Access Compliance Report

Public Rights-of-Way

(Curb Ramps)

Intersection ID: 28304	Main Street: LANCASTER_HY	Cross Street: JOHNSTON_RD	Location:	E
ADA ID: E10AD5232E31	Ramp Type: Perp	Initial Pass/Fail: Fail	Overall Compliance: No	Severity Score: 13.75
Codes/Mitigation Info/Possible Solution		Field Measurements/Component Compliance

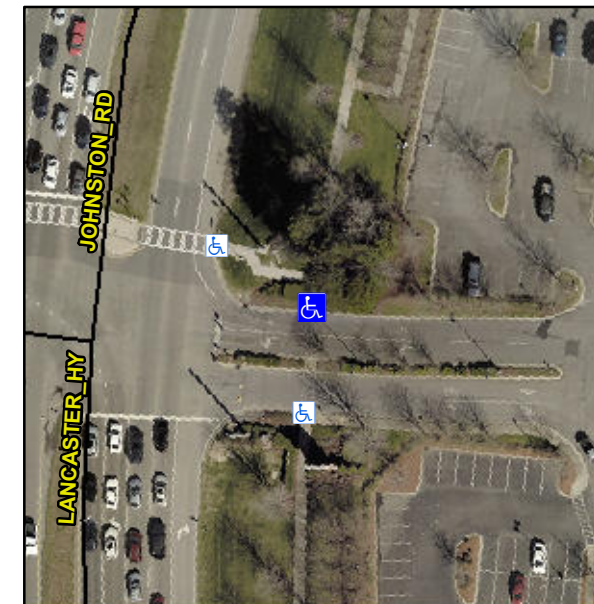
Not Found, R304.5.3

Compliance	Description	Data	Compliance	Description	Data
N/A	Ramp Length (in)	215.0	Yes	Ramp Slope (%)	8.5
Yes	Ramp Width (in)	71.5	No	Ramp XSlope (%)	2.3
N/A	Flare Type LT	N/A	N/A	Flare Type RT	N/A
N/A	Flare Slope LT (%)	N/A	N/A	Flare Slope RT (%)	N/A
N/A	Flare Traversable LT?	N/A	N/A	Flare Traversable RT?	N/A
N/A	Landing Length (in)	N/A	N/A	DWS Provided?	N/A
N/A	Landing Width (in)	N/A	N/A	DWS Contrast?	N/A
N/A	Landing Slope (%)	N/A	N/A	DWS Length (in)	N/A
N/A	Landing X Slope (%)	N/A	N/A	DWS Full Width?	N/A
N/A	Landing Curb? (Y/N)	N/A	N/A	DWS Offset (in)	N/A
N/A	Shared Landing?	N/A			
N/A	Gutter Ponding?	N/A	N/A	Gutter Slope (%)	N/A
N/A	Gutter Lip Ht (in)	N/A	N/A	Gutter X Slope (%)	N/A
N/A	Painted X Walk1?	Yes	N/A	Painted X Walk2?	N/A
	X Walk 1 Direction	To S		X Walk 2 Direction	N/A
N/A	X Walk 1 Width (in)	62.0	N/A	X Walk 2 Width (in)	N/A
	X Walk 1 Slope (%)	3.8		X Walk 2 Slope (%)	N/A
	X Walk 1 X Slope (%)	1.4		X Walk 2 X Slope (%)	N/A

Remove & Replace Entire Ramp.
